COMMISSION ON COMMUNITY INVESTMENT AND INFRASTRUCTURE

RESOLUTION NO. 47-2022

CONDITIONALLY APPROVING THE SCHEMATIC DESIGN FOR THE TRANSBAY BLOCK 3 PARK AND STREETScape IMPROVEMENTS PROJECT; ADOPTING ENVIRONMENTAL FINDINGS PURSUANT TO THE CALIFORNIA ENVIRONMENTAL QUALITY ACT; AND PROVIDING NOTICE THAT THIS ACTION IS WITHIN THE SCOPE OF THE TRANSBAY TERMINAL / CALTRAIN DOWNTOWN EXTENSION / REDEVELOPMENT PROJECT FINAL ENVIRONMENTAL IMPACT STATEMENT / ENVIRONMENTAL IMPACT REPORT (“FEIS/EIR”), A PROGRAM EIR, AND IS ADEQUATELY DESCRIBED IN THE FEIS/EIR FOR PURPOSES OF THE CALIFORNIA ENVIRONMENTAL QUALITY ACT; TRANSBAY REDEVELOPMENT PROJECT AREA

Schematic Design for the Transbay Block 3 Park and Streetscape Improvements Project

RIGHT-OF-WAY SCOPE OF IMPROVEMENTS

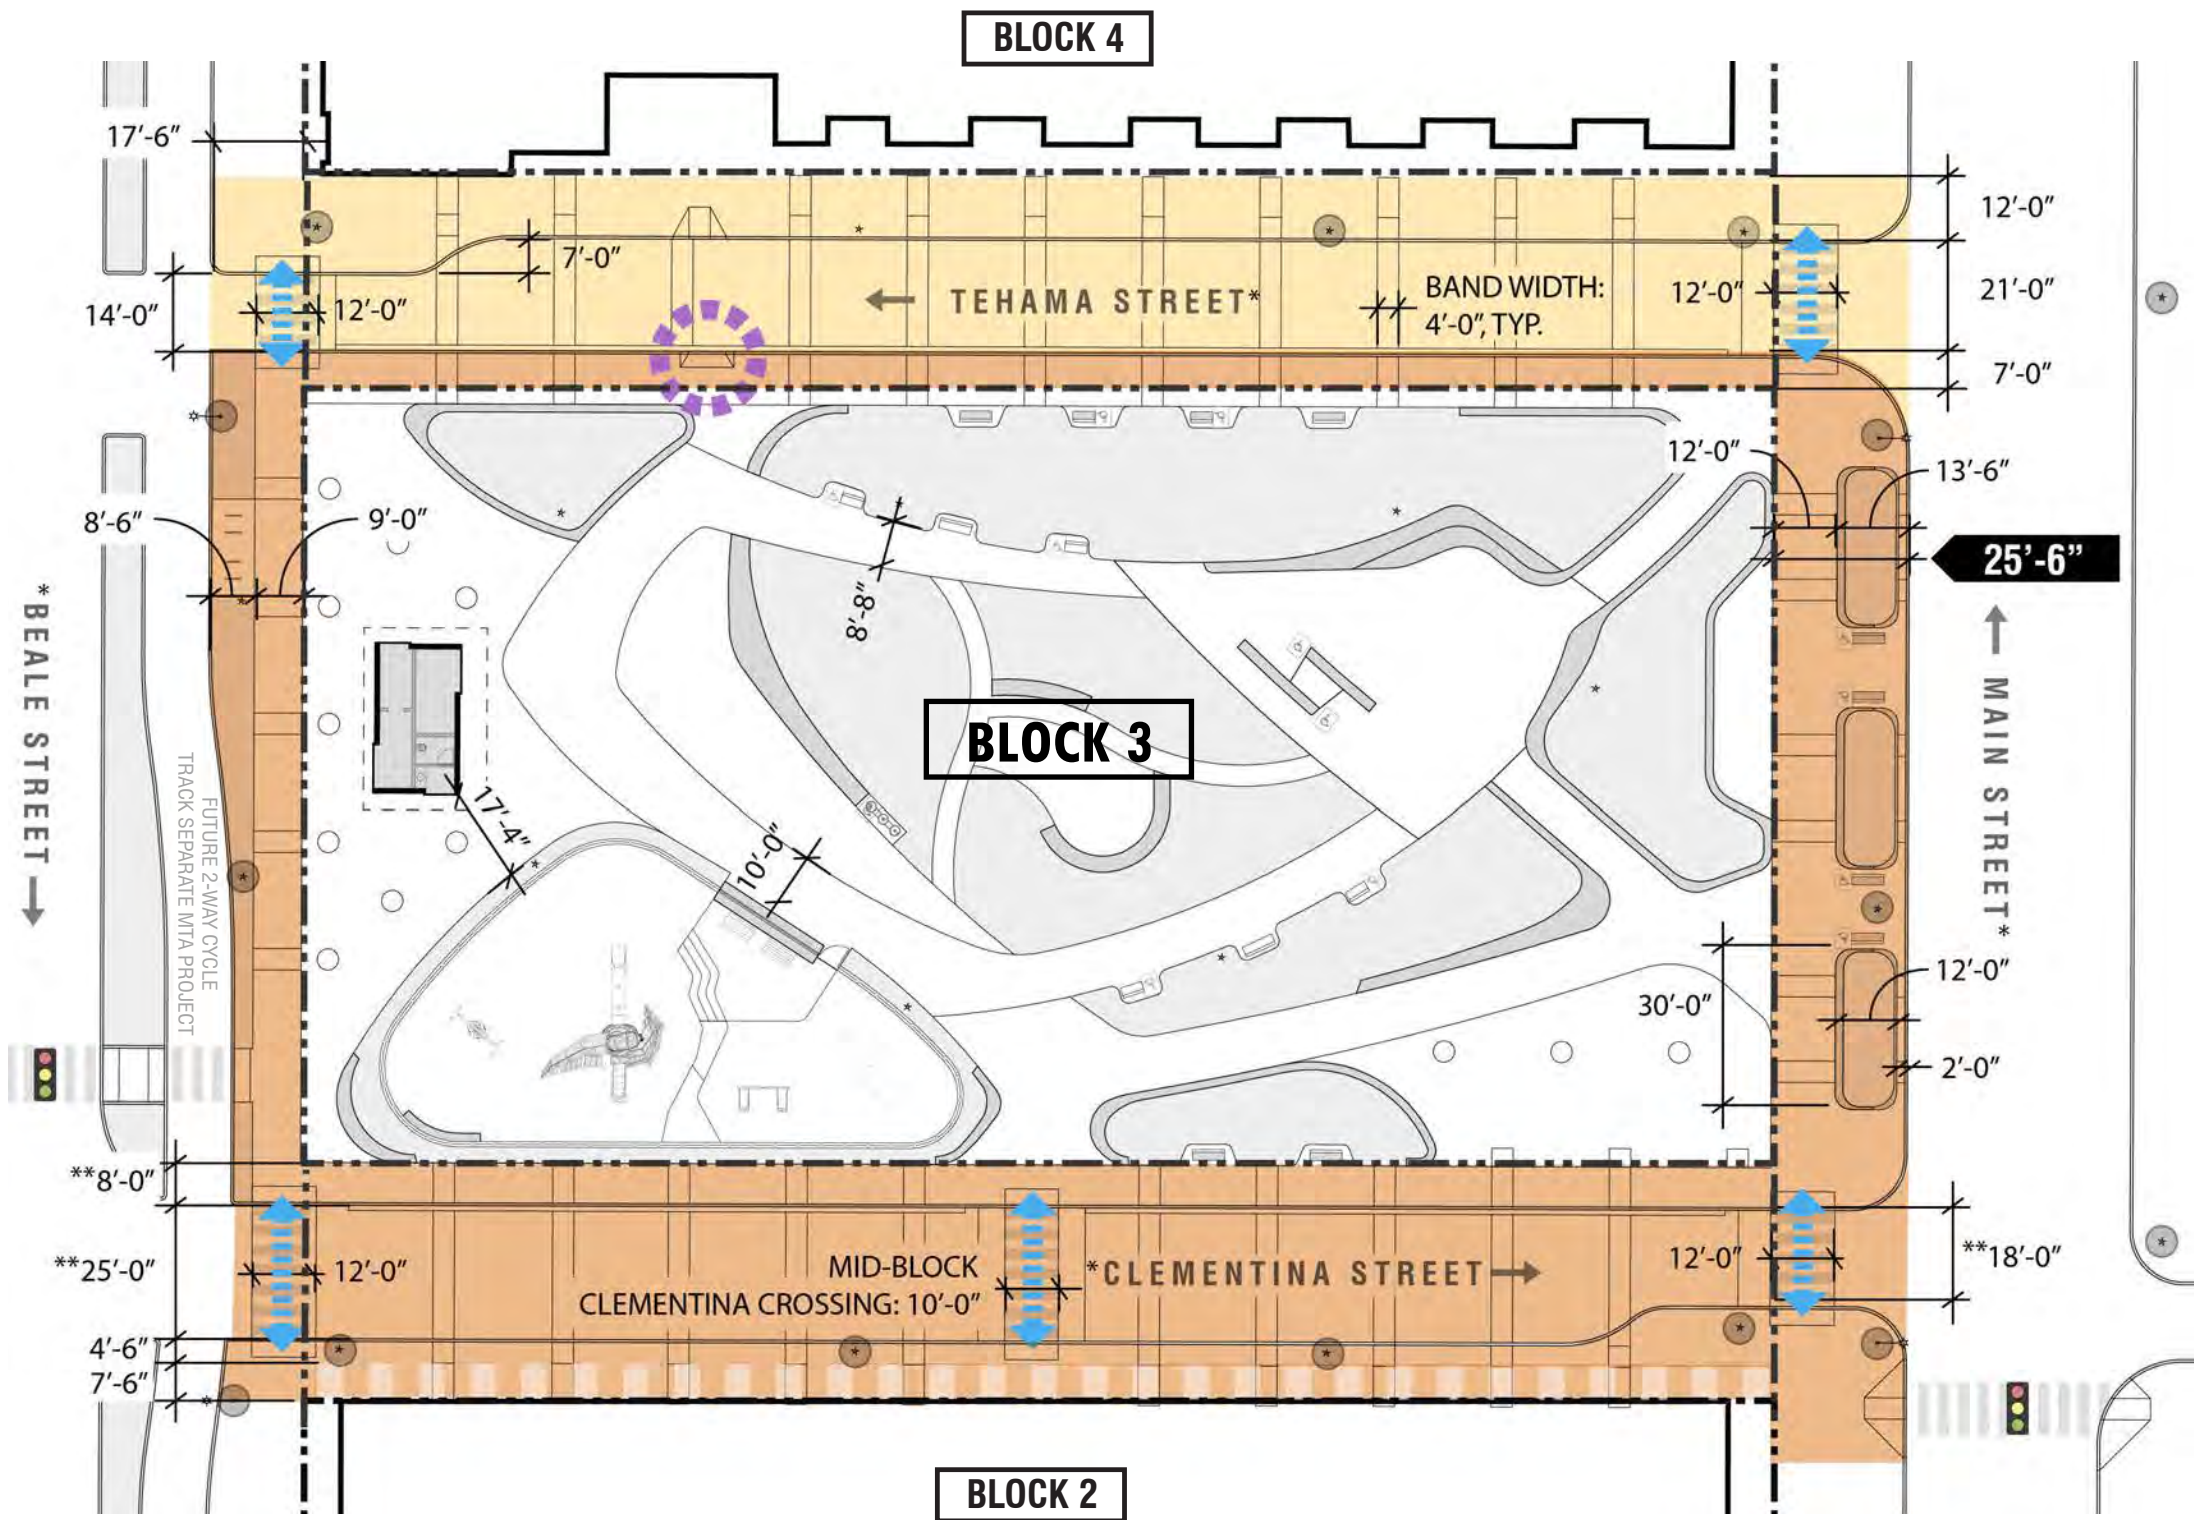
8. **Streetscape Configuration.**
 - a. SFPW shall continue to refine the design and materiality of streetscape improvements for Beale, Main, and Tehama Streets flanking the Park. Streetscape elements for Tehama, Clementina, Beale, and Main Streets are subject to change, pending subsequent City Department requirements.

- b. In the event that the final Construction typology for Transbay Block 2 triggers a change in fire code for emergency vehicle access to Clementina Street, the Clementina drive aisle width may be revised, and the sidewalk and street section shall be redesigned accordingly. For example, Clementina Street drive aisle width may be reduced by 4' overall (to allow for 12' wide northern sidewalk) if Block 2 construction type is confirmed to be Type I.
